Response-to-Comment to Environmental Assessment Report

Comments from Environmental Protection Department, dated 5 January 2026

Section 12A Rezoning Application for Proposed Columbarium on Various Lots in D.D. 41, Sha Tau Kok, New Territories

Environmental Assessment Report

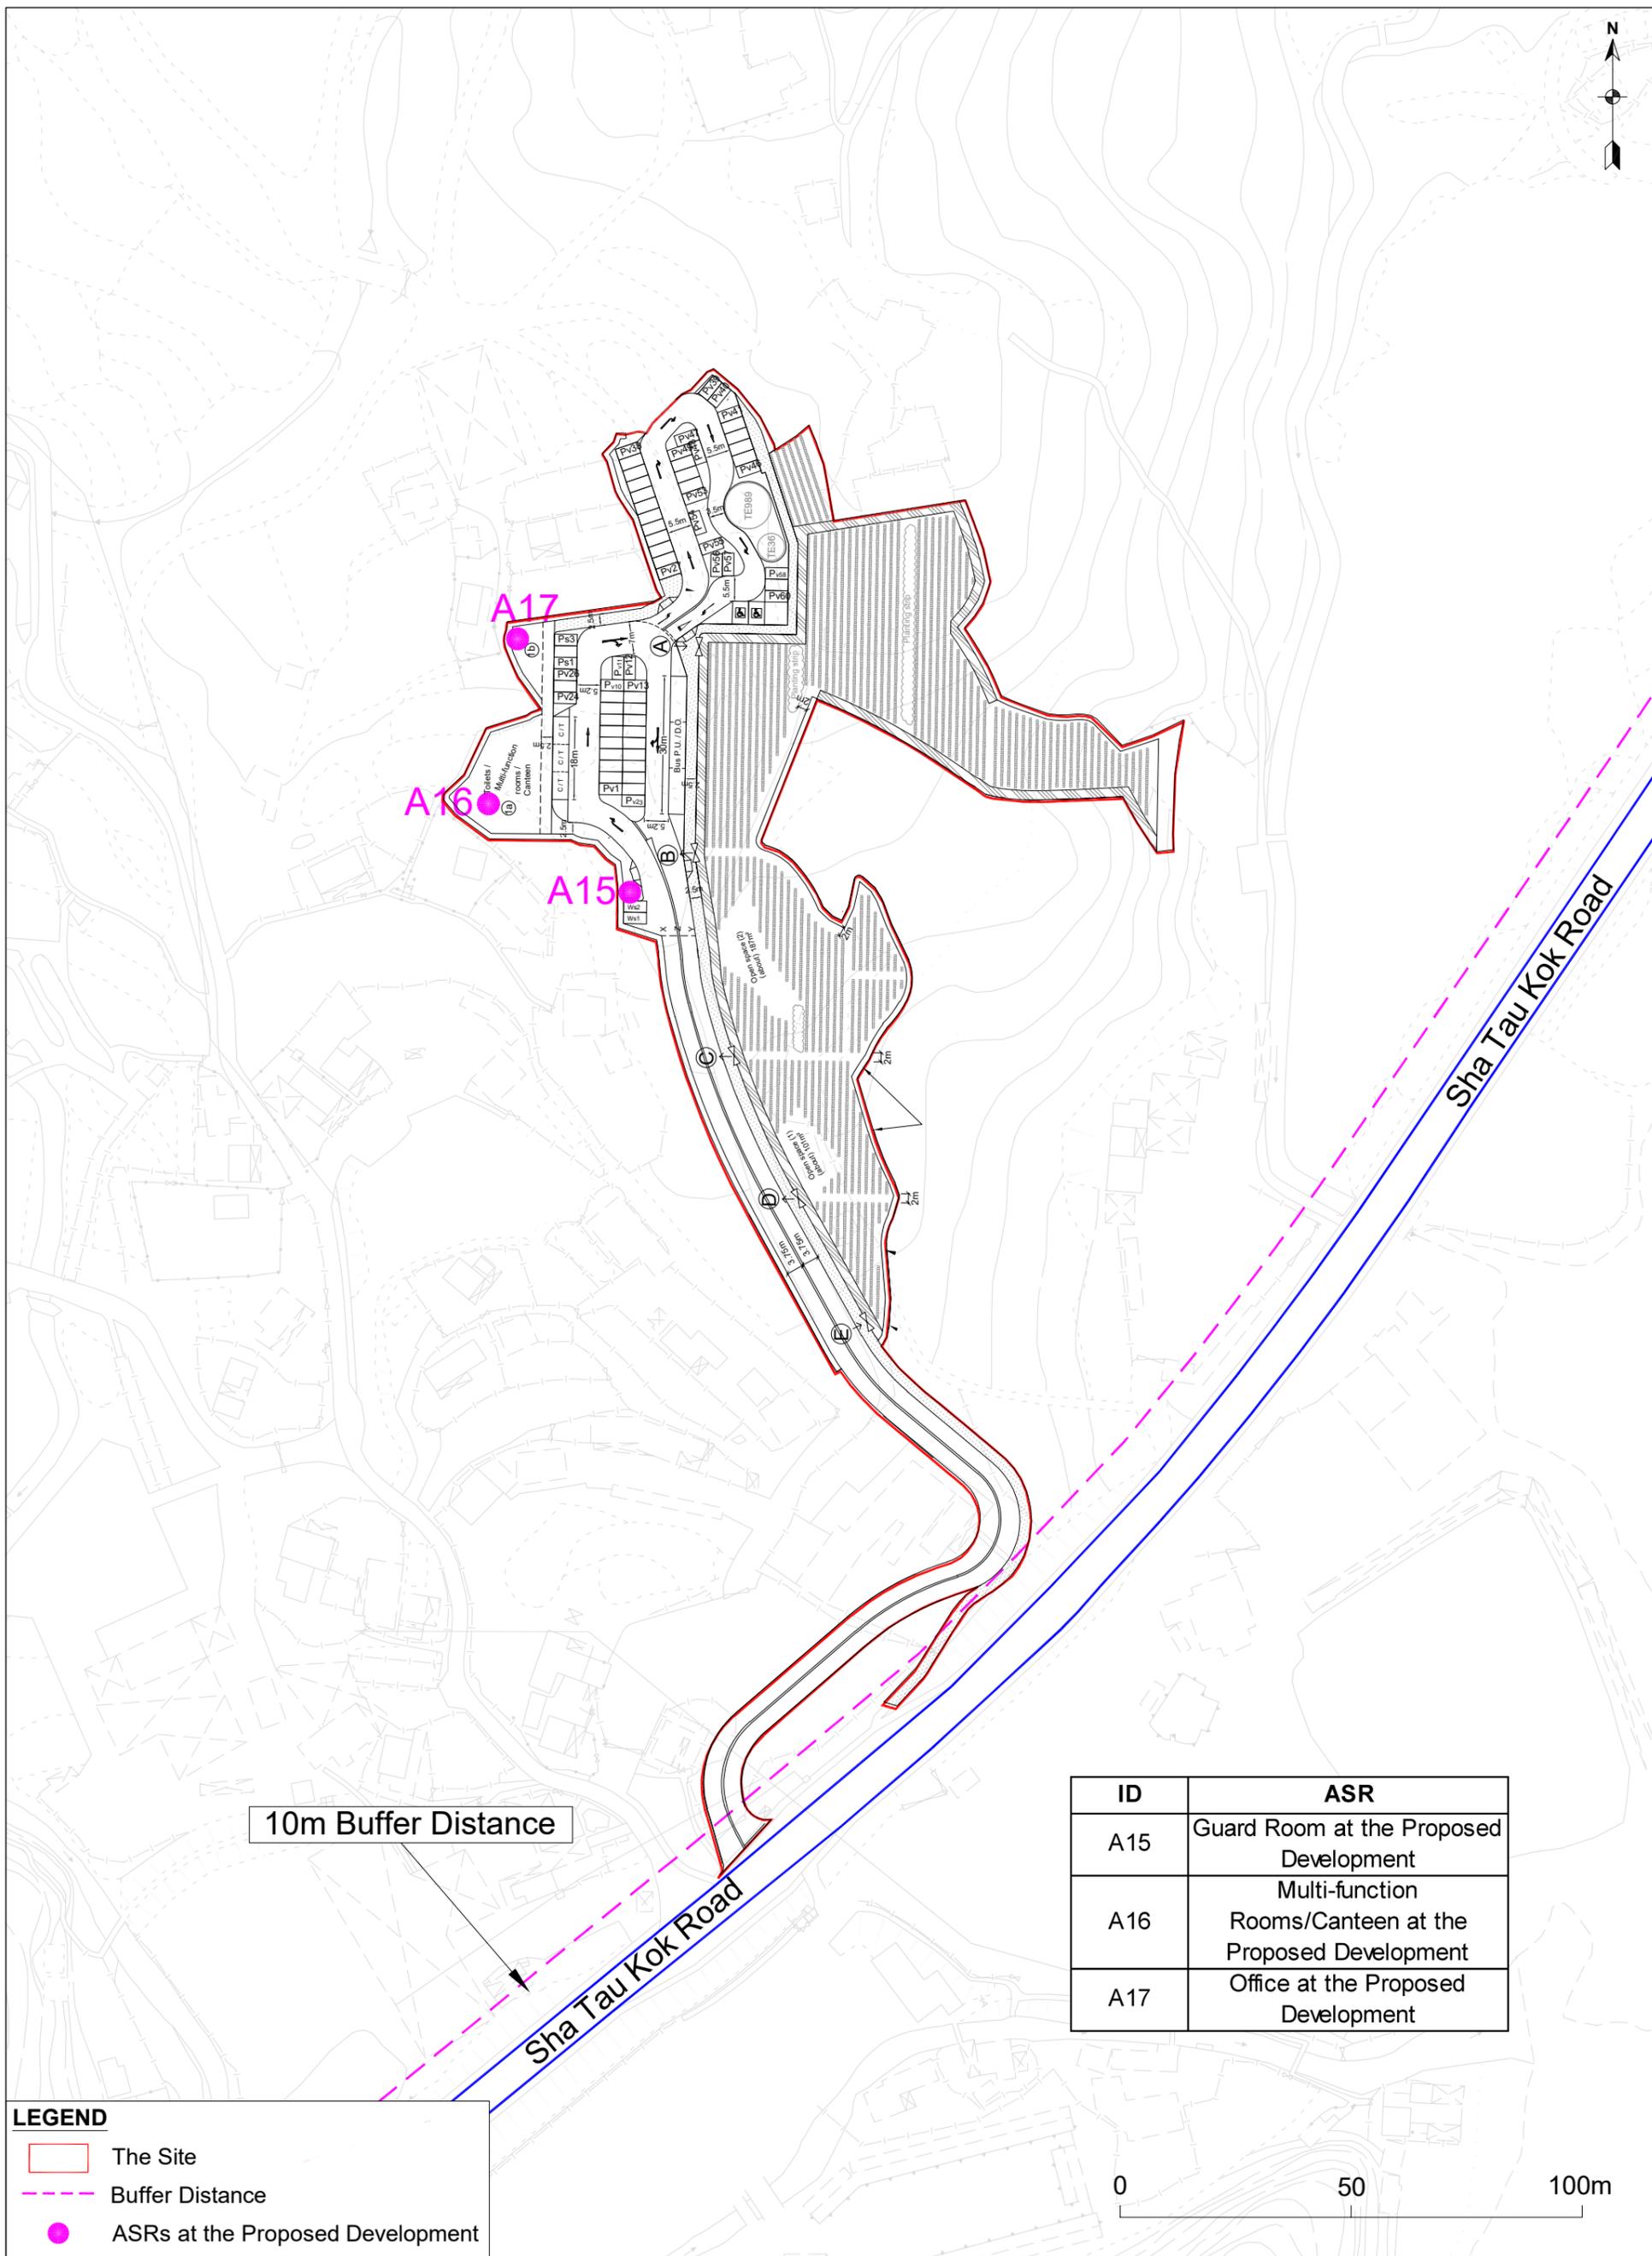
Items	Comments	Response
6	Section 3.7.3: Please specify the date of the site survey.	Noted and specified. Please refer to Section 3.8.3.
7	Figure 3.1: Please overlay the PATH grid onto the figure.	Noted and revised. Please refer to Figure 3.1.
Noise		
8	Section 2.2: Please confirm if the proposed development include new roads/road improvement works.	Noted. It is confirmed that there is a proposed vehicular road located at the southern portion of the Site. Please refer to Section 2.2.
9	Section 4.5.1: Please provide the TD endorsement on traffic forecast in Year 2045.	TD has no comment on traffic forecast in Year 2045.
10	Appendix D: <ul style="list-style-type: none"> - According to Table 4.2, there are 12 NSRs. Please specific the locations of NSRs in Table 4.5 and Appendix D. Please assess the impact for each representative NSR. - Please provide a noise model or spreadsheet to show the calculation of prediction. 	<ul style="list-style-type: none"> - According to EIAO Guidance Note No. 12/2023, Clause 4.7.7, calculation of road traffic noise level has been conducted. The results showed that there will not be significant contribution to the cumulative road traffic and would not cause the overall road traffic noise level to increase by 1.0 dB(A) or more. - Ditto

Figure 3.3

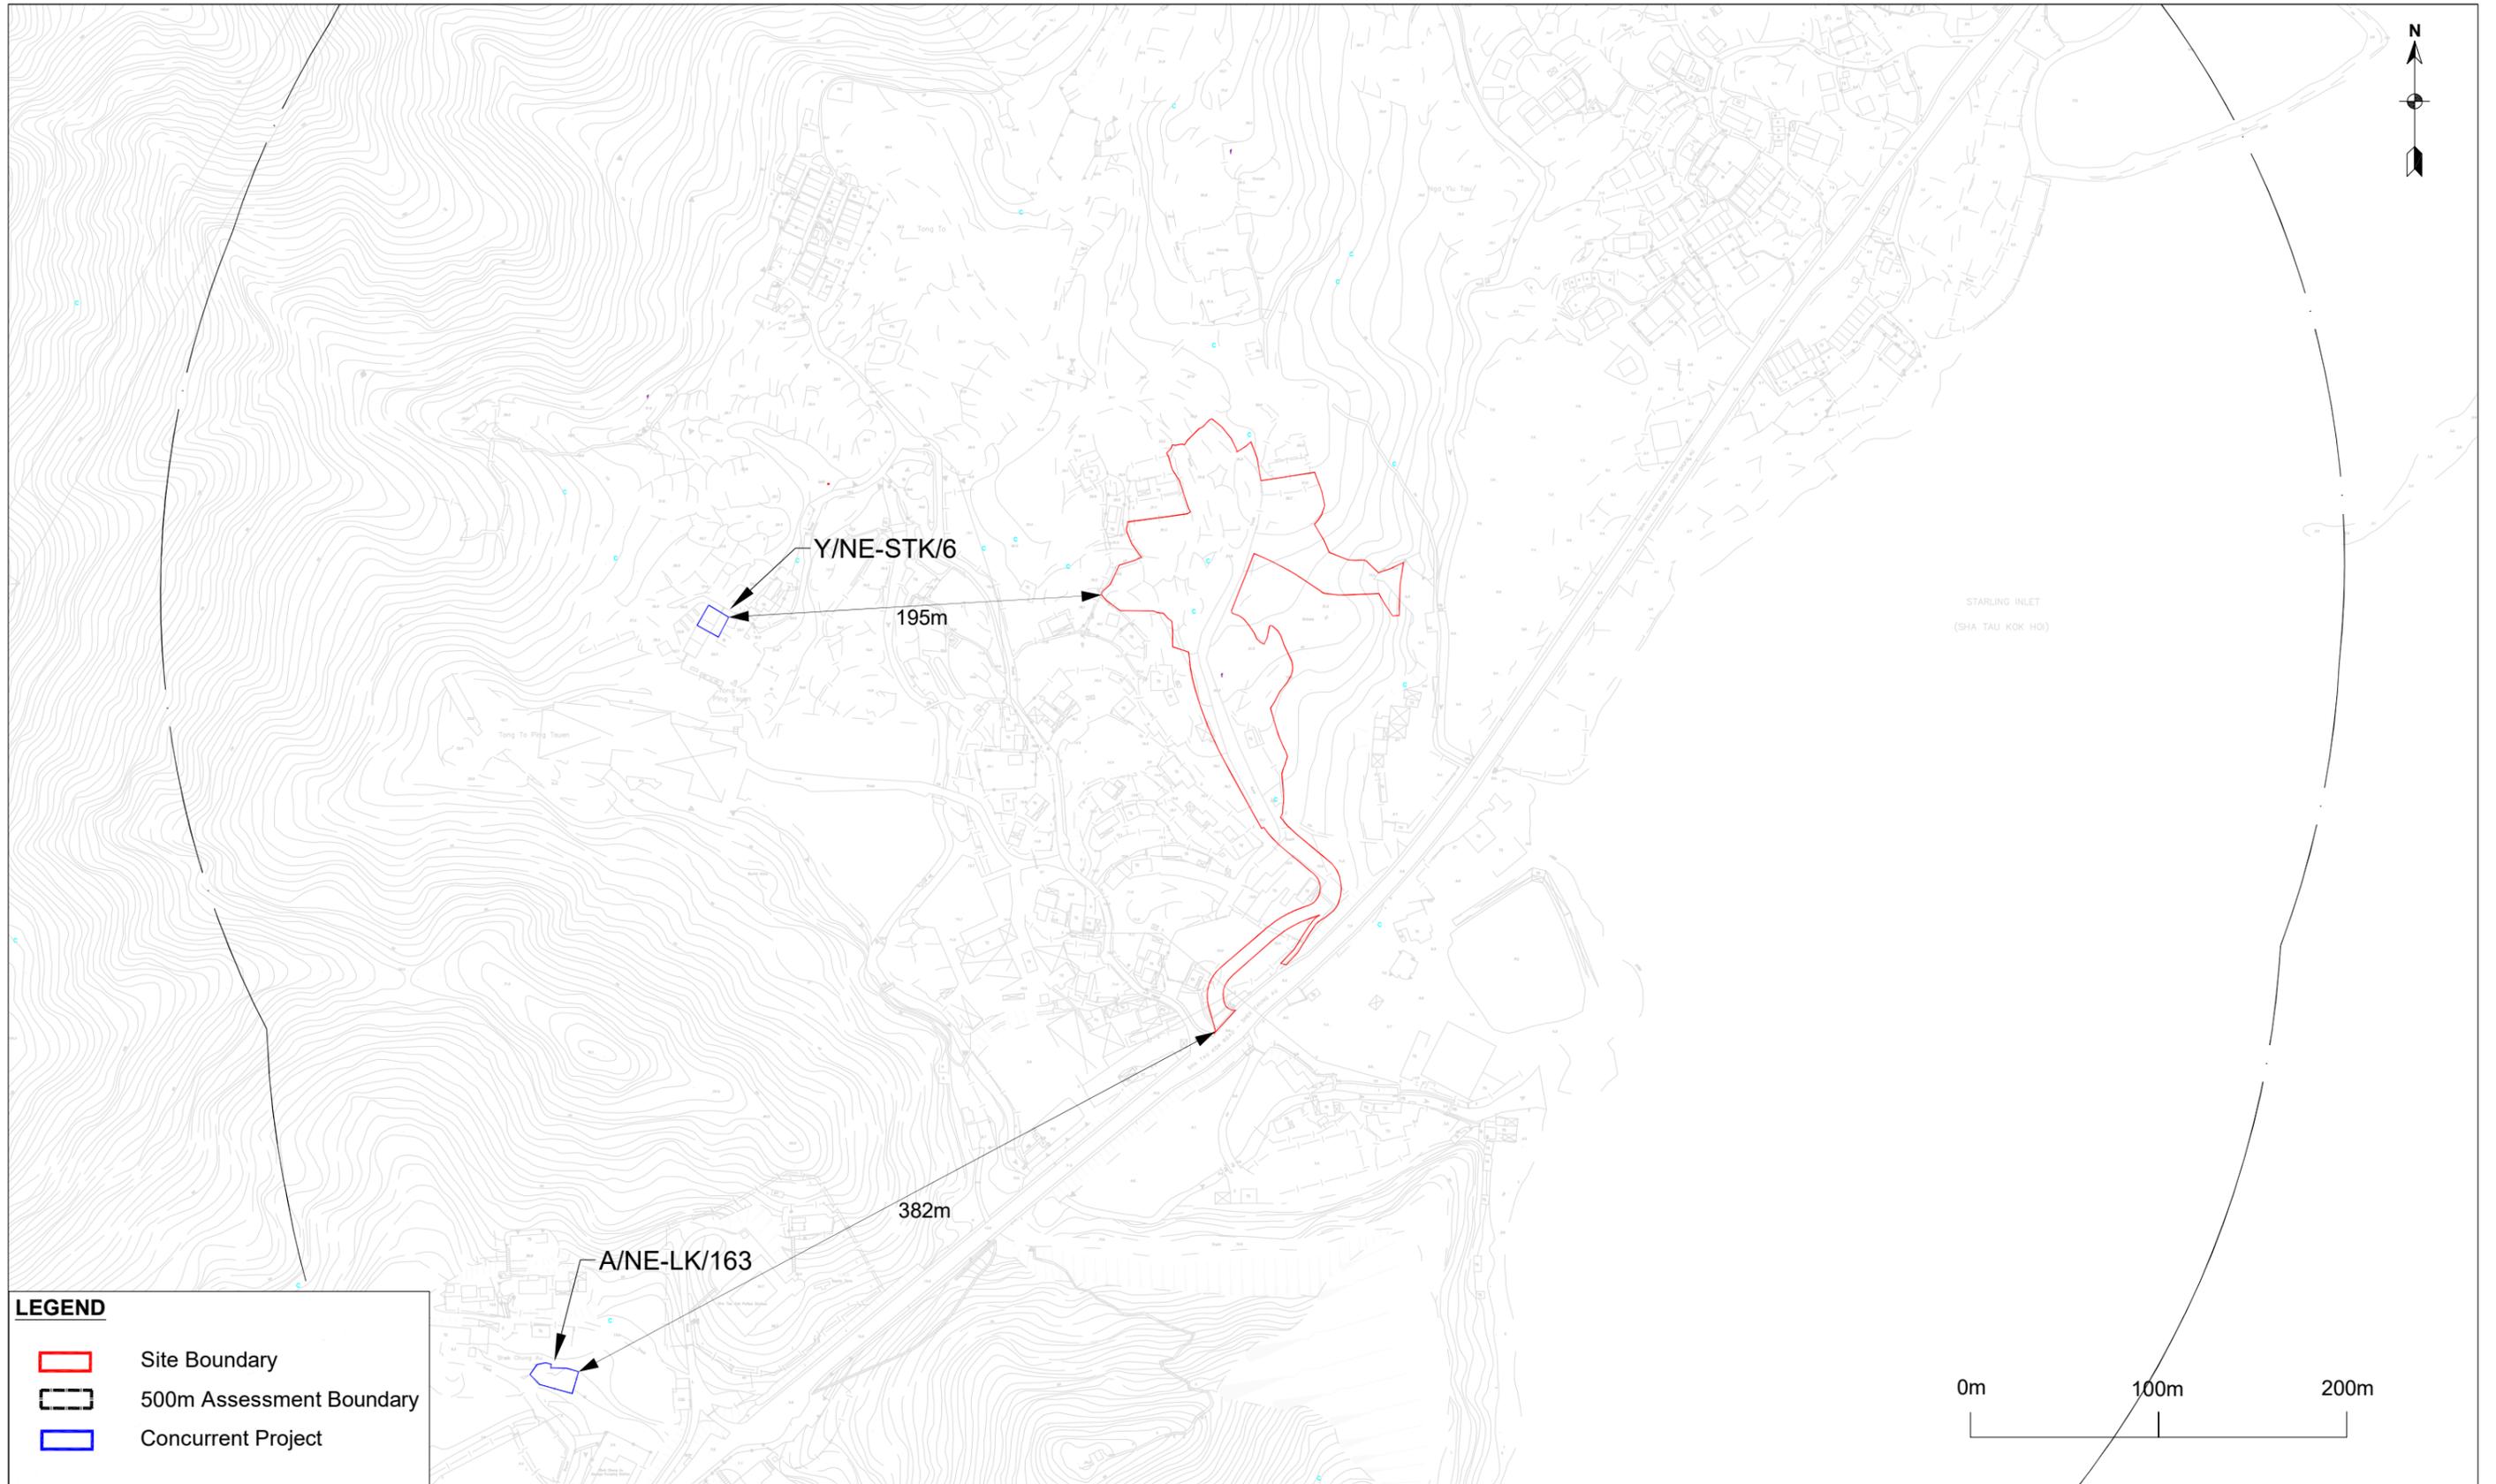
5	Section 3.6: Please check for any concurrent works in the surrounding area and, if present, assess their cumulative impact as needed.	Noted and revised. The summary of concurrent project is provided in Section 3.7.
